Proposal for amendments to UN Regulation No. 43 (Safety glazing)

The aim of this proposal is to specify clearly the parameters of the abrasion test machine.

Annex 3, Figure 4, shall be replaced by this diagram:

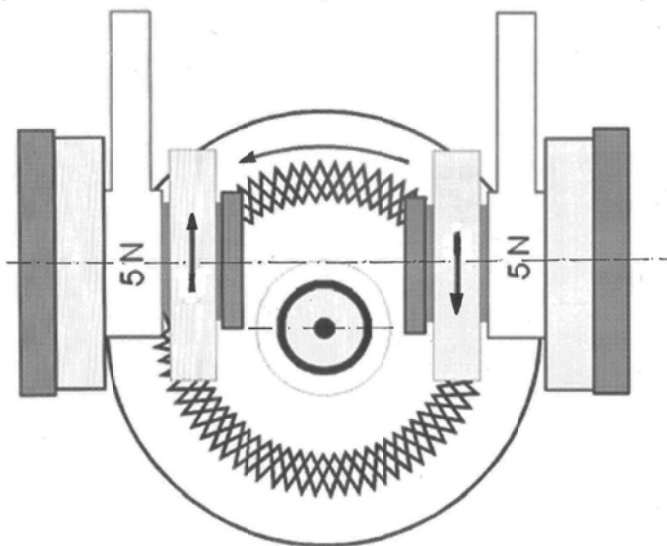
1. The offset of the axis and the distance of the wheels are not specified and Figure 4 shows no offset between the axes. However, this offset and this distance have an extremely high influence to the sliding between the wheels and the glass, i.e. to the abrading effect; therefore they shall be specified by all means.
 2. Description of the method shall comply with the parameters of the Taber instrument which is referred in the Regulation.
-

"The distance between the symmetry planes of the wheels shall be 65 mm and the offset of the wheel axis from the turntable axis shall be 19 mm.

Wheels shall seat evenly on the specimen in their full width so that abrasion shall be nearly the same in the full width of the abraded area. Abraded particles shall be sucked away during the test so that they do not influence abrasion."
